ONE COURSE CEMENT CONCRETE SIDEWALK
ITEM 560

REVISIONS AND CORRECTIONS

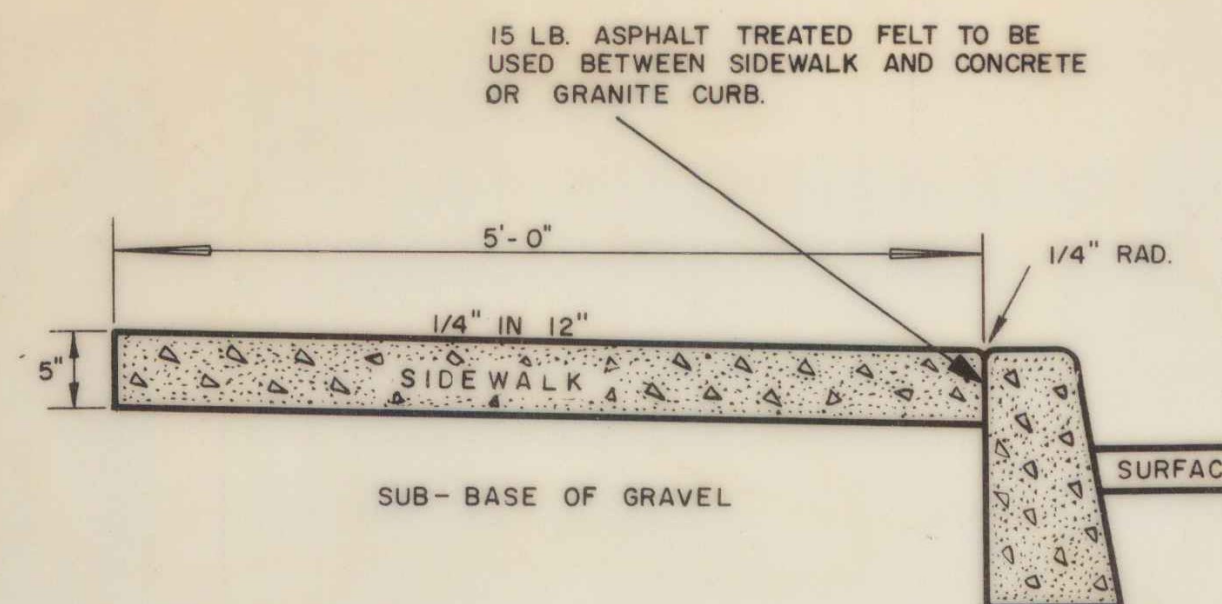
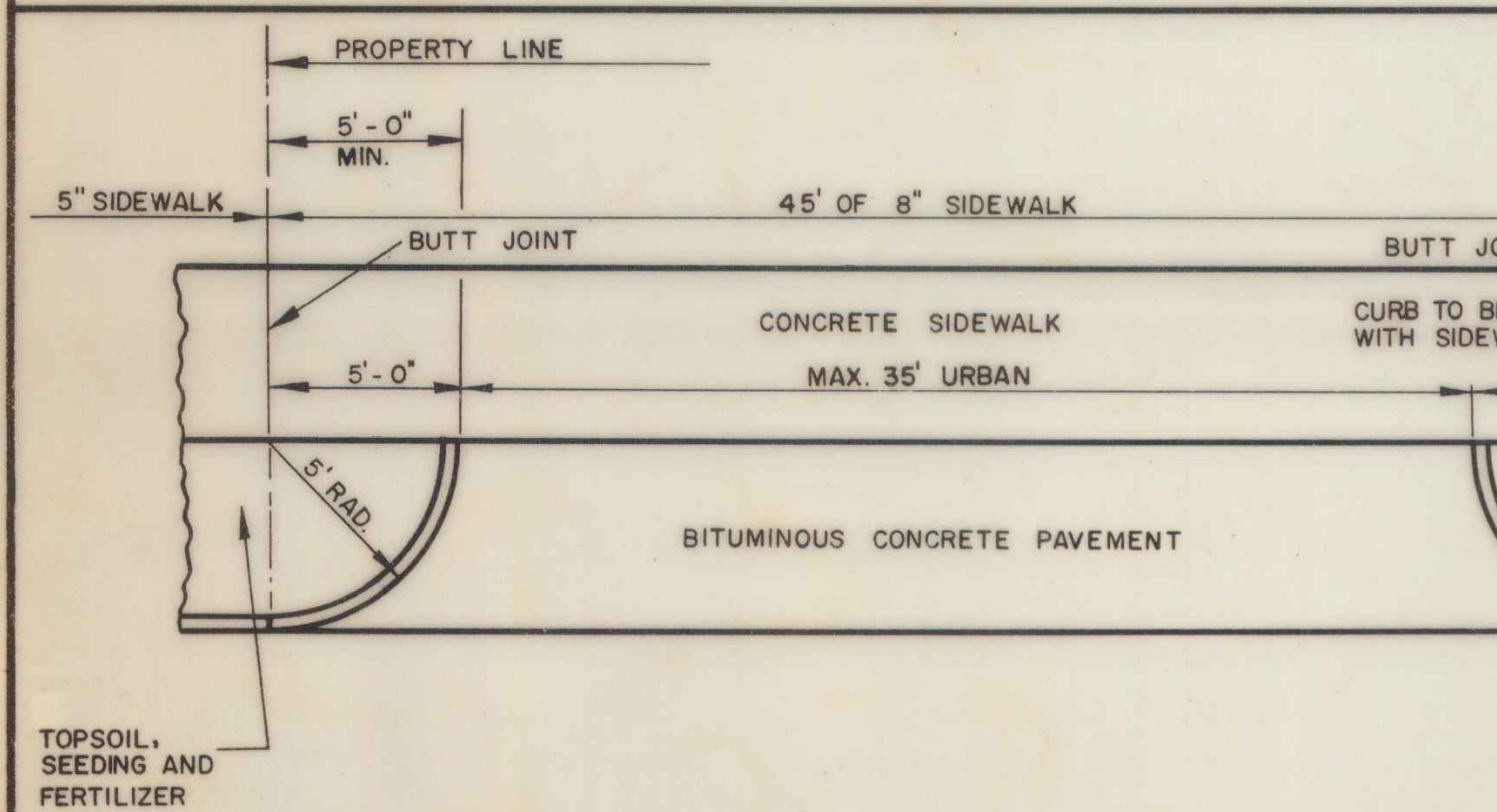
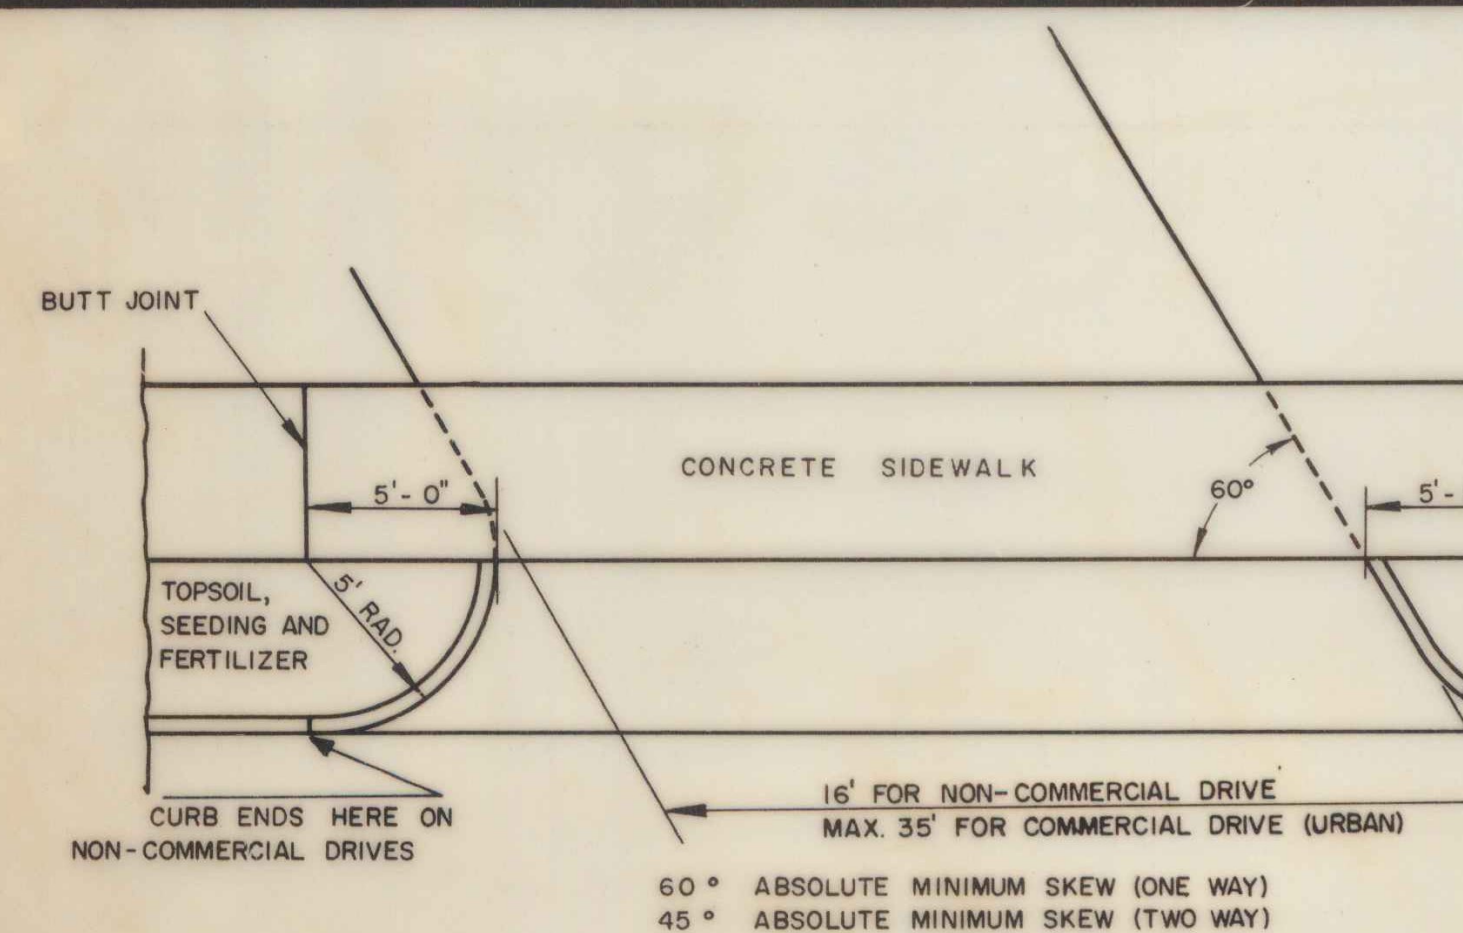
THIS SHEET AND C-2 1/2 SUPERCEDE SHEET C-2 APPROVED MAY 26, 1958
WORDS "CONCRETE CURB" ADDED. DIMENSIONS CHANGED ON "TYPICAL
DRIVE WITH 4' SIDEWALK." GRADE CHANGED AND NOTE ADDED ON
"TYPICAL DRIVE WITH 5' SIDEWALK." JUNE 12, 1959
MAR. 1, 1965. HEIGHT OF STRAIGHT CURBING ENDS, AT DRIVES, REDUCED
FROM 1 1/2' TO 1'. RAMP SLOPES CHANGED FROM 3/4" IN 12"
TO VARIABLE.
